# AEROPLANES

## Index of Assemblies

DRG. NO. ARA4099 G/A.6 / 53

SHEET 3

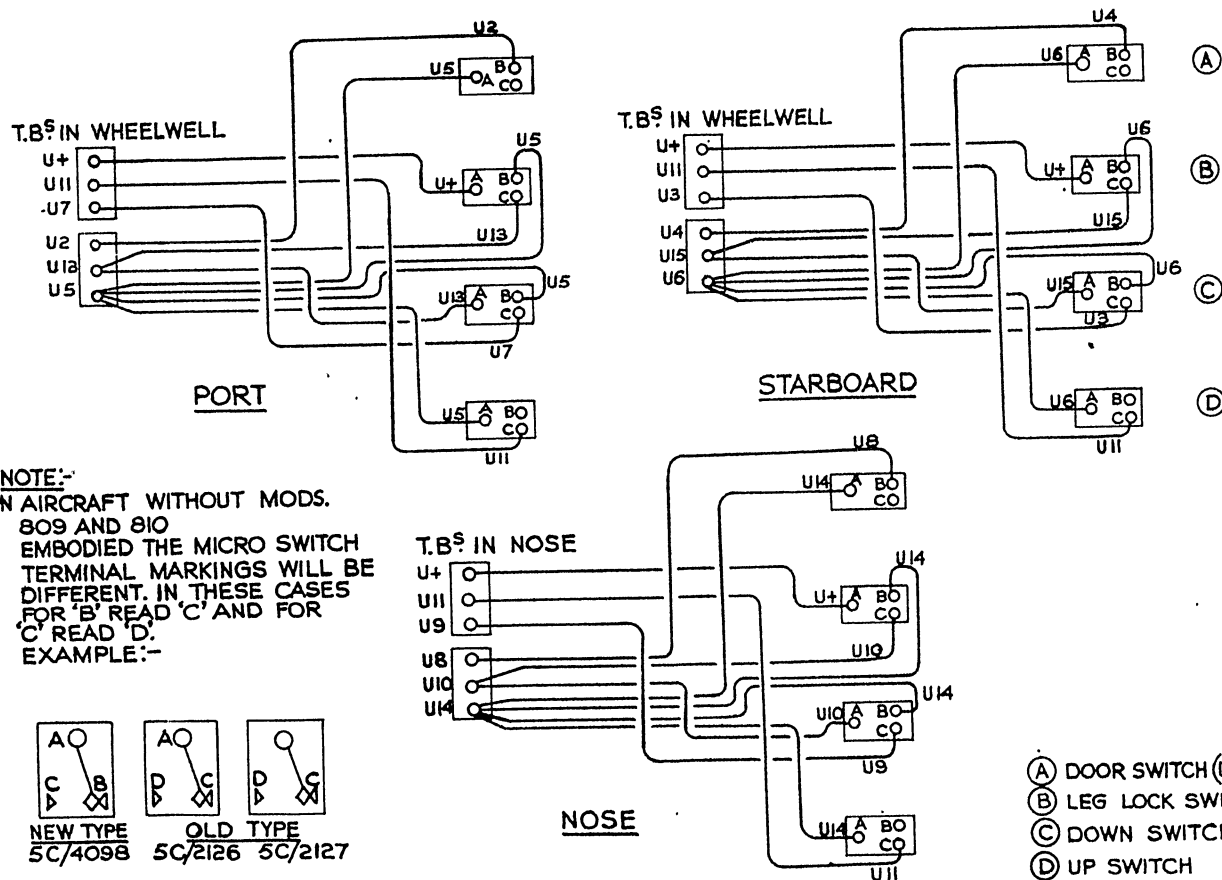
*Note:*—On aircraft without Mod. No. Vampire/809 embodied, the micro-switch markings will be found to differ from those shown in the wiring diagrams. In these cases, read the markings as given in the example in Sheet 3 of the drawing. At the "UP" switch and "LEG LOCK" switch, it will be found that there is a redundant lead which must be taped back and insulated.

NOTE:-  
ON AIRCRAFT WITHOUT MODS.  
809 AND 810  
EMBODIED THE MICRO SWITCH  
TERMINAL MARKINGS WILL BE  
DIFFERENT. IN THESE CASES  
FOR 'B' READ 'C' AND FOR  
'C' READ 'D'.  
EXAMPLE:-

SHEET 4

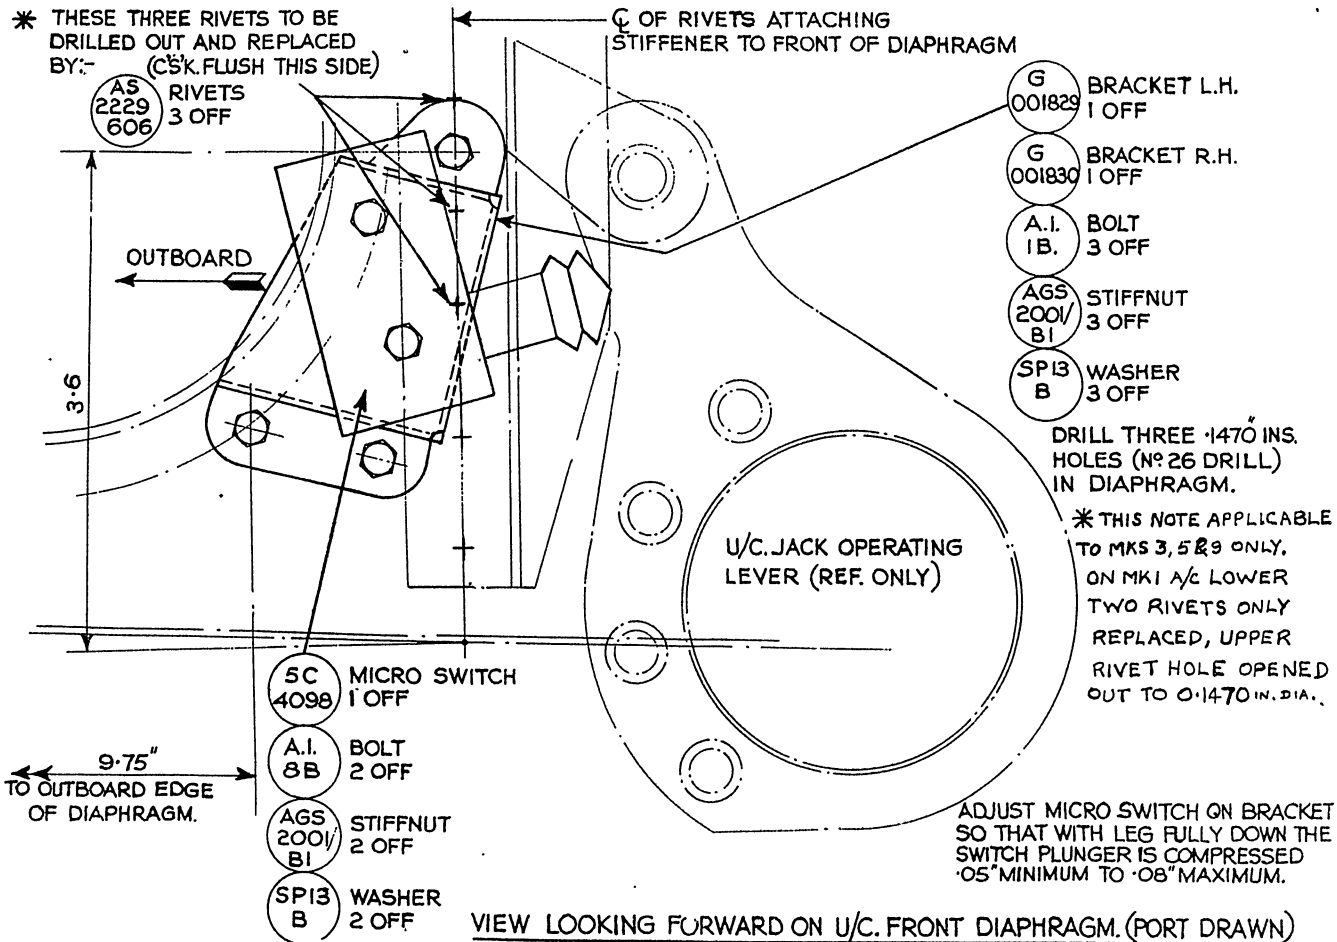
(9) Refer to Sheet 4 of the drawing, and locate the position for the new micro-switch assembly in the port wheel well. Remove the three rivets indicated on the drawing and replace with new countersunk rivets, Part No. AS.2229/606, the heads of which are to be flush on the rear face of the stiffener. To facilitate this work and the fitting of the switch assembly, first remove the small inspection panel on the under surface of the wing, just forward of the diaphragm.

(11) Refer to Sheet 4 of the drawing, and scribe a line parallel to the centre line of the stiffener and 9.75 in. from the outboard edge of the diaphragm.

(13) Remove the bracket and fit the new micro-switch (Stores Ref. 5C/4098) to it with bolts, nuts and washers as shown in Sheet 4 of the drawing. Connect up the cable, Part No. NOO 2659, to the micro-switch with the coding U.13, U.5. and U.7 going to terminals A, B, and U.7 going to terminals A, B and C respectively.

DRG. No A.P. 4099 G/B.11 / 53  
SHEET 5

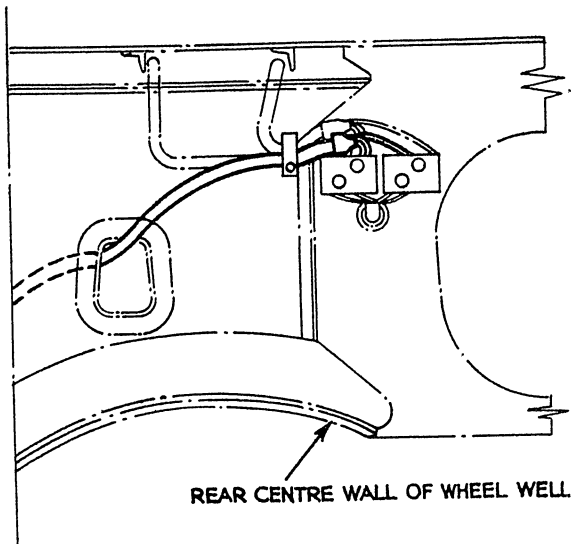
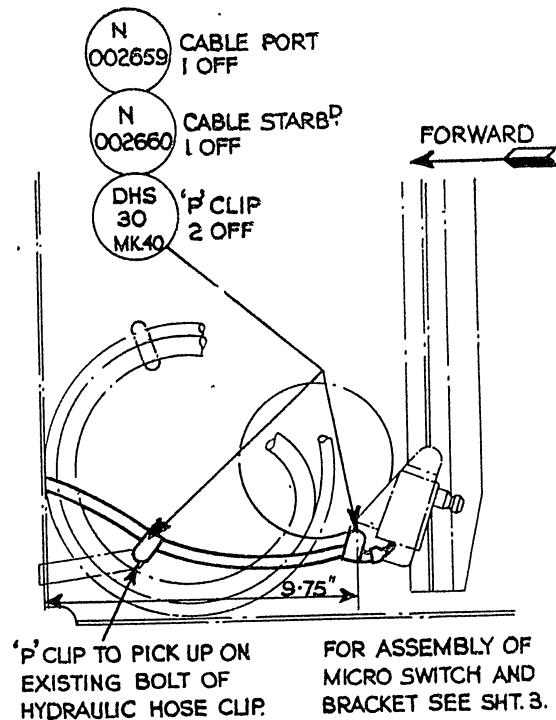
(14) Offer up and bolt the assembly to the diaphragm, using the nuts, bolts and washers shown in Sheet 4 of the drawing. Run the cable and clip as shown in Sheet 5 of the drawing. Bind under the clips with one in. wide polyvinyl tape.

INSTALLATION OF CABLE ASSEMBLY TO 'DOWN' SWITCH IN PORT U/C. (SIMILAR FOR STARB<sup>D</sup>)

SHEET 1

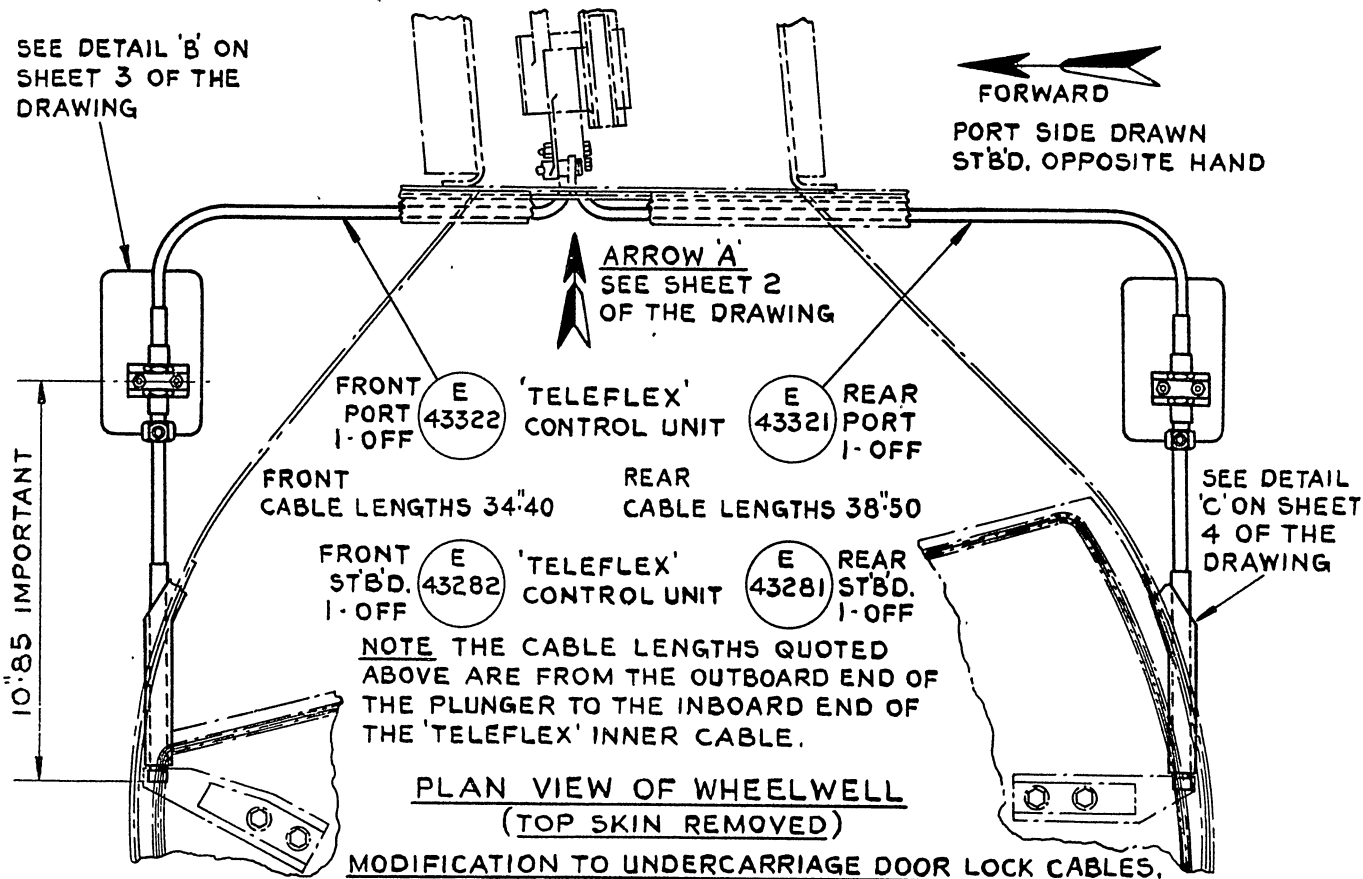
(21) Apply pigmented varnish jointing compound to the faying surfaces of each forward and aft new lock barrel and adjacent wheelwell wall, and, sliding the barrels over the lock plungers, secure the barrels into position with eighteen new bolts, Part No. AS.1246/2C and two new bolts, Part No. AS.1246/3C, as shown on Sheets 1 and 4 of the drawing.

SHEET 2

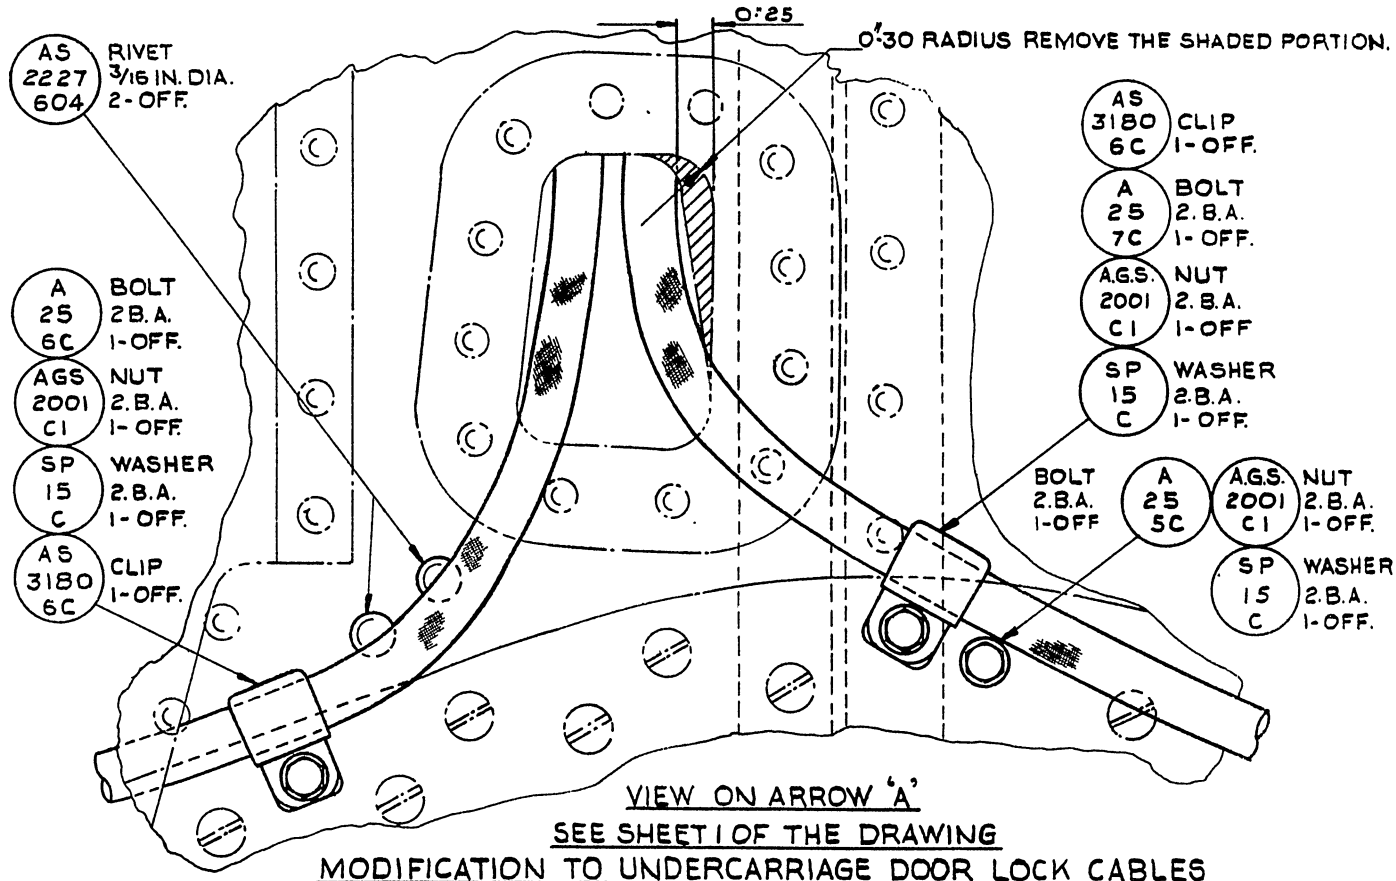
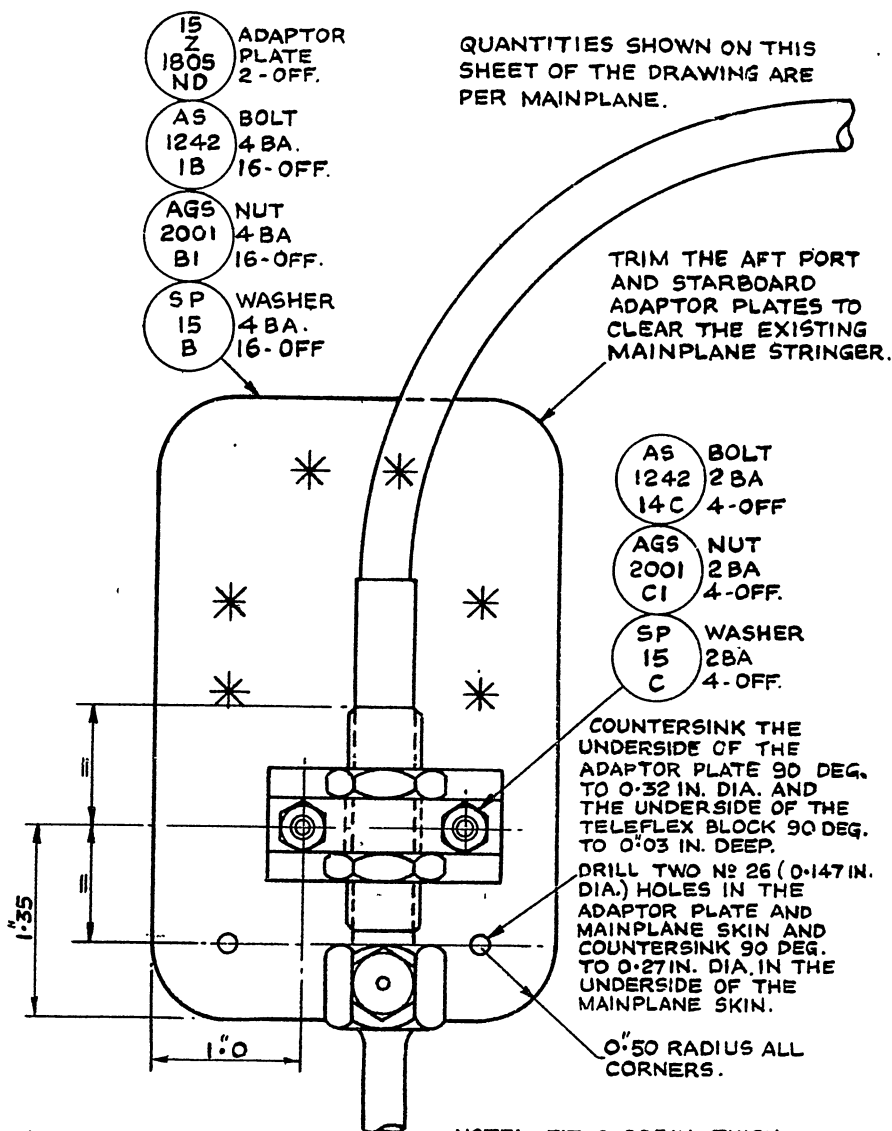
(6) On the inboard side of the wheelwell wall and referring to Sheet 2 of the drawing, carefully mark out and file away the shaded portion of the reinforced hole, as shown. Remove all burrs and file marks, and polish the filed area.

(7) Referring to Sheet 2 of the drawing, fill in the two redundant holes which were previously used for attaching the forward Teleflex clamp to the inboard wheelwell wall, with two  $\frac{3}{16}$  in. dia. rivets, Part No. AS.2227/604. Fill in the aft redundant hole which was previously used for attaching the rear Teleflex clamp to the wheelwell wall, with one new 2 B.A. bolt, washer and nut, Part Nos. A.25/5C, SP.15/C and AGS.2001/C1 respectively. This is also shown on Sheet 2 of the drawing. The remaining forward attachment hole of the rear Teleflex clamp is to be used for attaching a new cable clip, as detailed in a later operation.

(22) Remove one existing countersunk bolt from the inboard side of the wheelwell and secure the forward lock control cable at this point with one new 'P' clip, 2 B.A. bolt, washer and nut, Part Nos. AS.3180/6C, A.25/6C, SP.15/C and AGS.2001/C1 respectively, as shown on Sheet 2 of the drawing. Secure the rear lock cables to the existing hole in the inboard wheelwell wall, with one new 'P' clip, 2 B.A. bolt, washer and nut, Part No. AS.3180/6C, A.25/7C, SP.15/C and AGS.2001/C1 respectively, which is also shown on Sheet 2 of the drawing.

**INSTALLATION OF POWER FAILURE WARNING LAMP ON BLIND FLYING PANEL.**

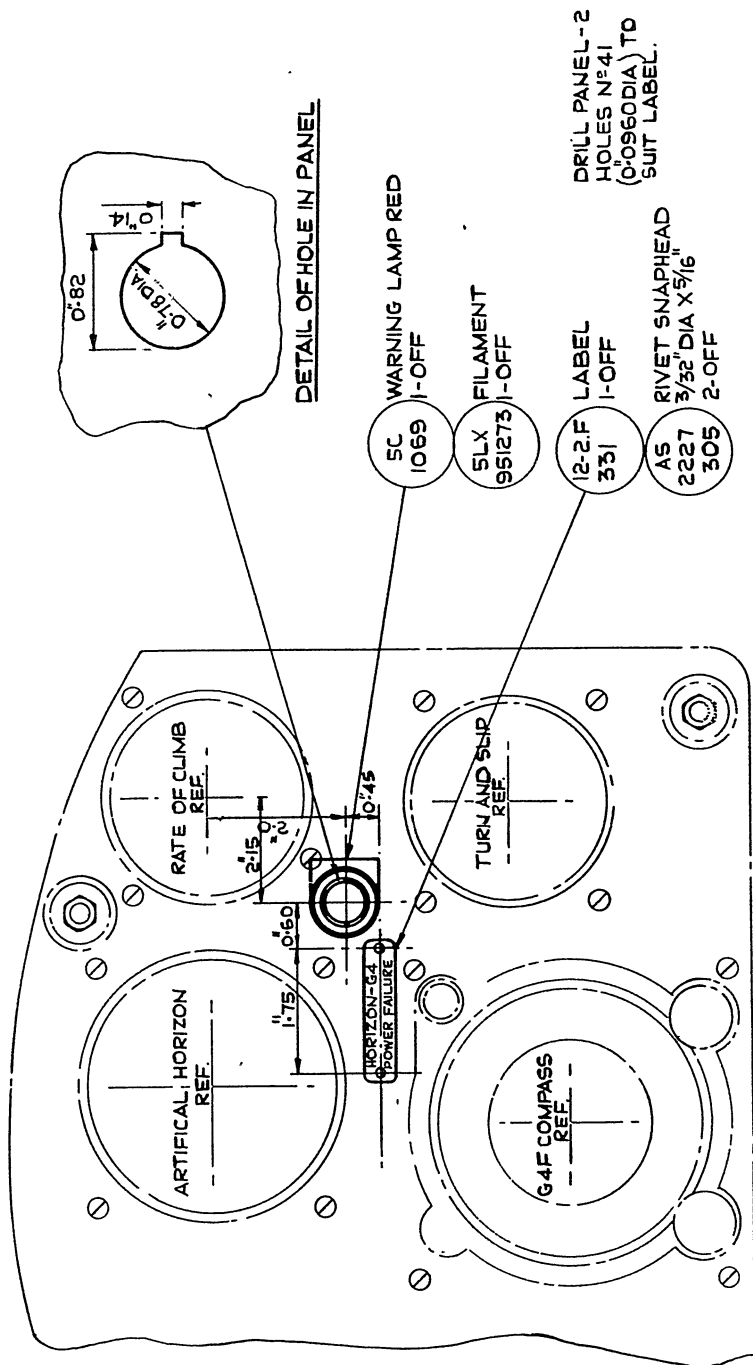
(4) Mark out and cut the hole in the blind flying panel for the red warning lamp as shown on Sheet 2 of drawing. Position the "Horizon-G4 Power Failure" label, Part No. 12-2F.331, as shown, and using the holes in the label as guides, drill two holes in the panel to suit, using a No. 41 (0.0960 in. dia.) drill. Remove the label, deburr the holes and clear the panel of swarf.

(5) Secure the label to the panel using two  $\frac{3}{32}$  in. dia. snaphead rivets, Part No. AS.2227/305, assemble the red warning lamp (Stores Ref. 5CX/1069) and filament (Stores Ref. 5LX/951273) and secure to the panel as shown on Sheet 2 of drawing.
